## ADDENDUM NO. 2

Issue Date: April 25, 2023

Project Name: Phase I – Cell 3 Site Preparation Class 1 Landfill – Segment 3 Expansion

Bid Number: 2023040

TITLE: **BASE GRADING PLAN - SEGMENT 3 EXPANSION**

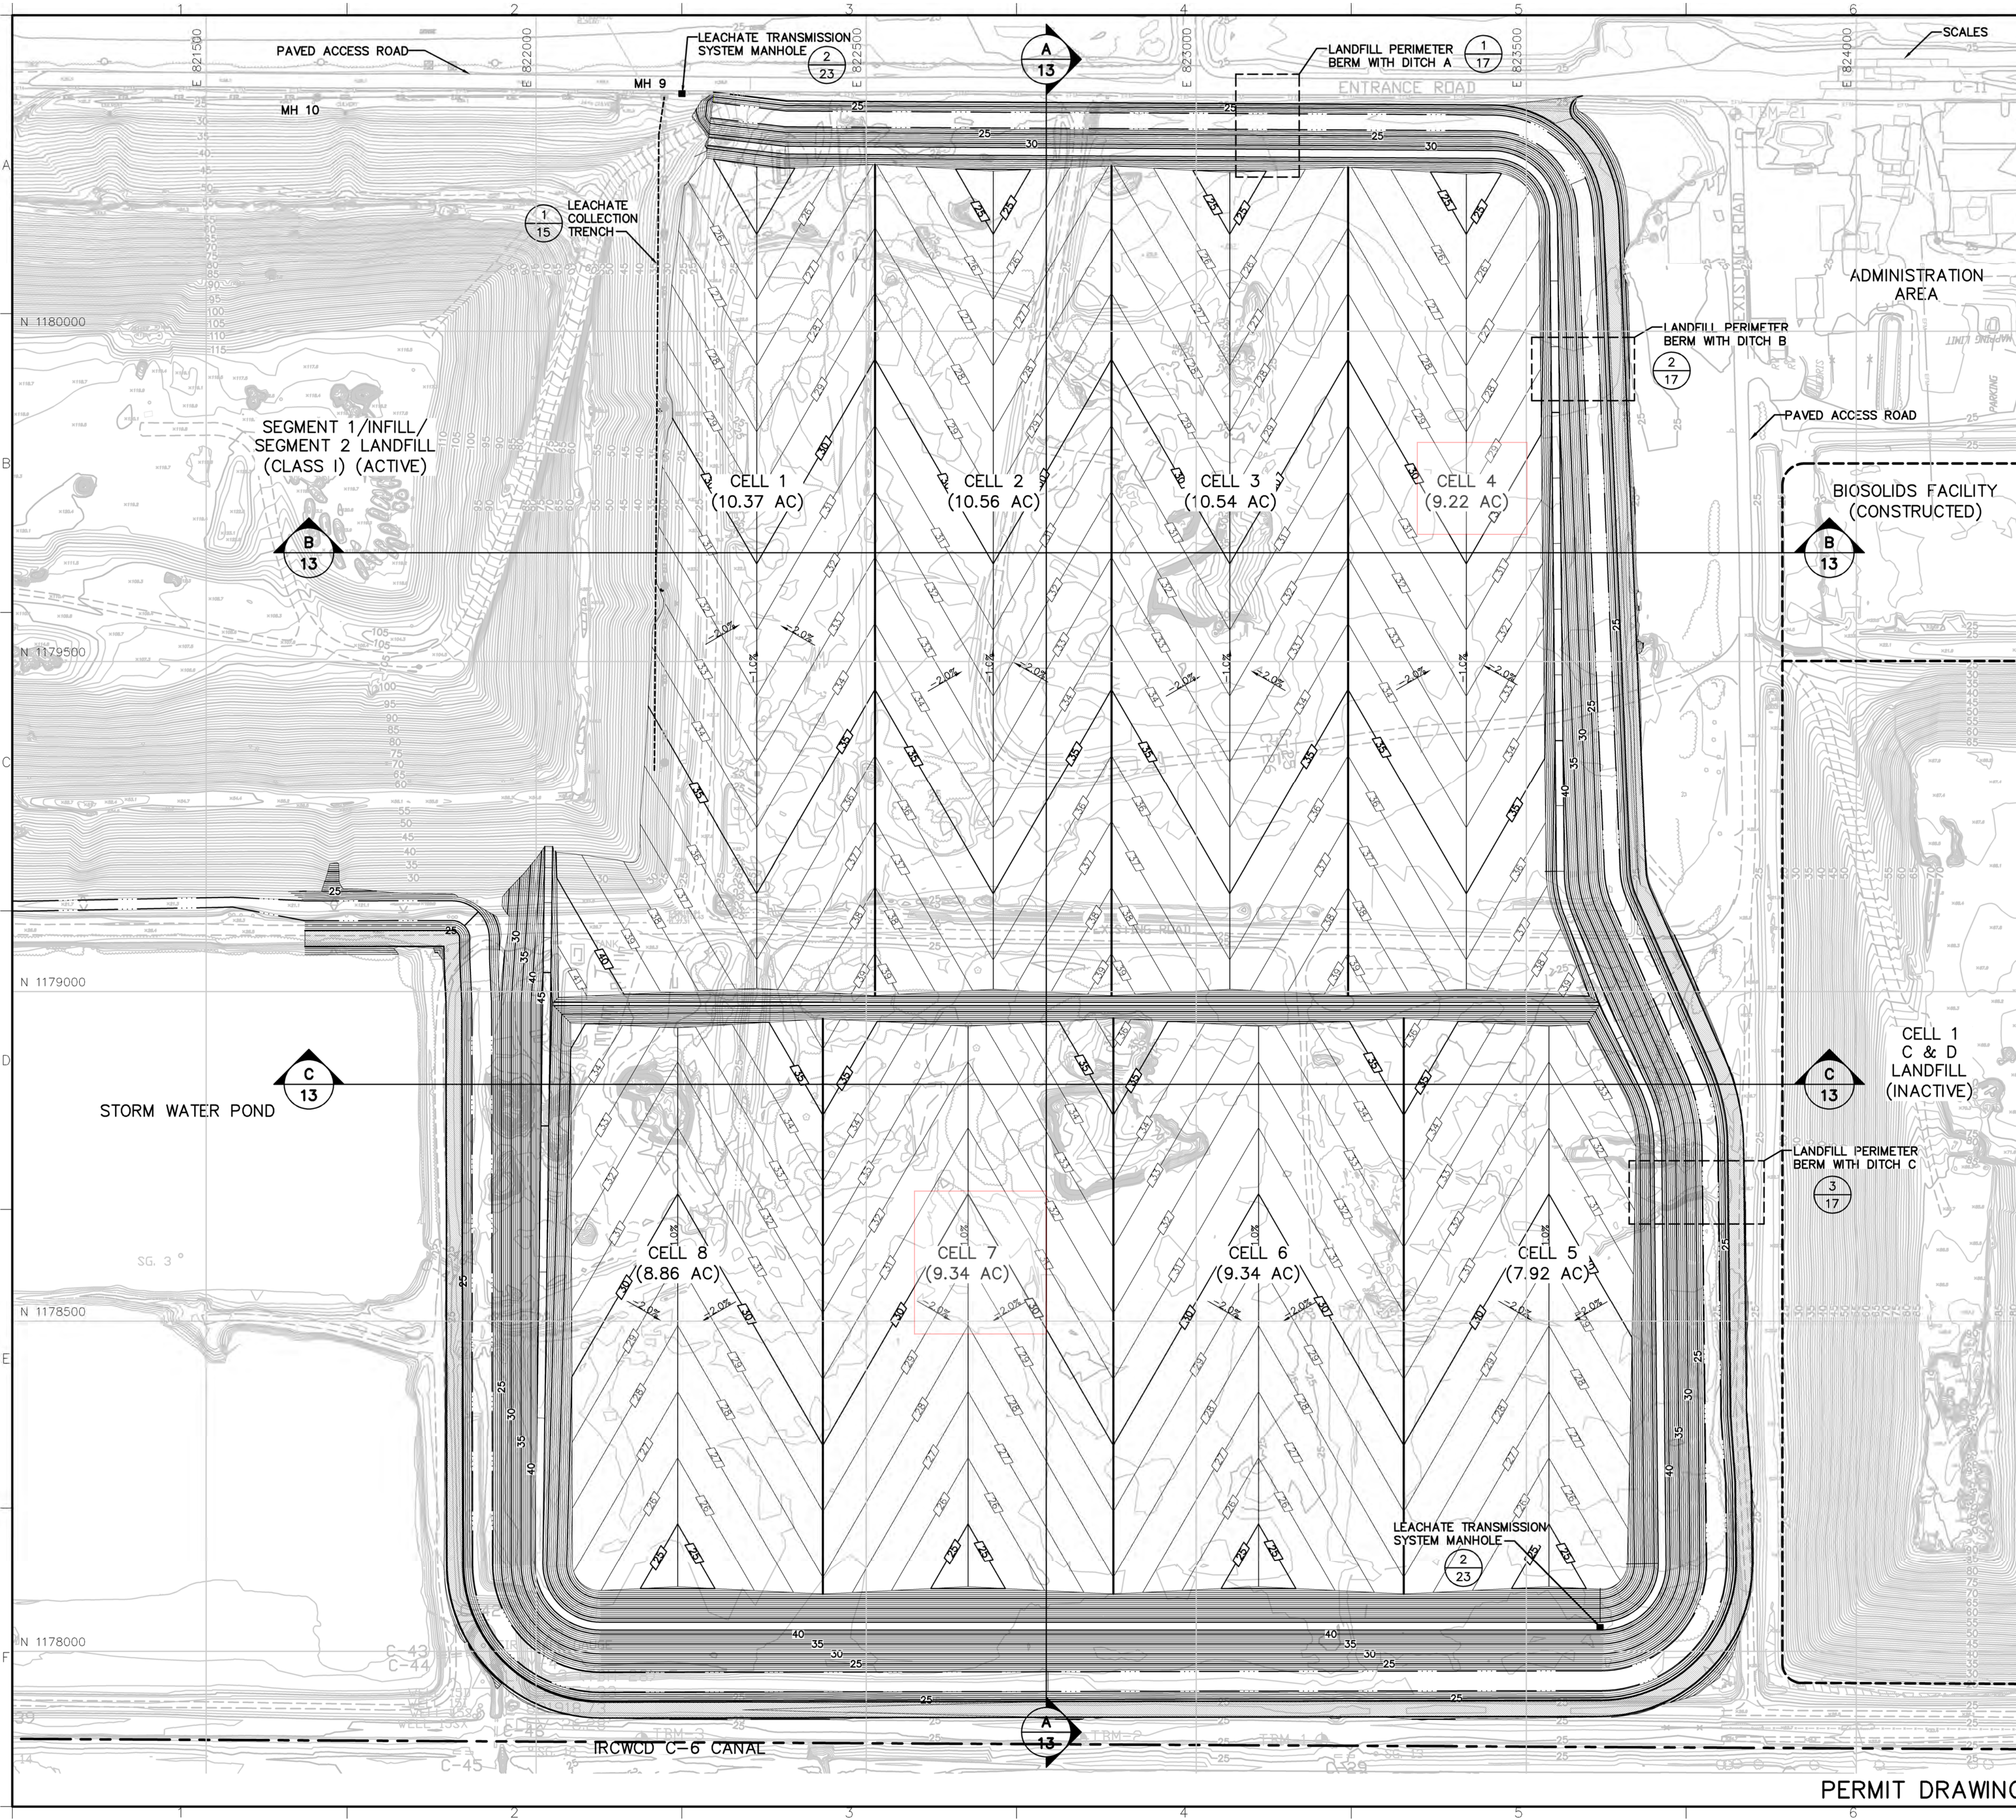
15. The Legend on Drawing 3 shows both an "Existing Forcemain" and a "Leachate Forcemain". The plan also shows a line that appears to be a forcemain. However, there is no call out or any other mention of this forcemain on any of the other drawings, nor are there any details. Also, there appears to be no mention of any work associated with a forcmeain in the specifications. Please confirm that we will not be required to perform any work with any forcemain, existing, proposed, or otherwise.

**No force main work will be required. These are existing force main as part of Existing Site Conditions.**
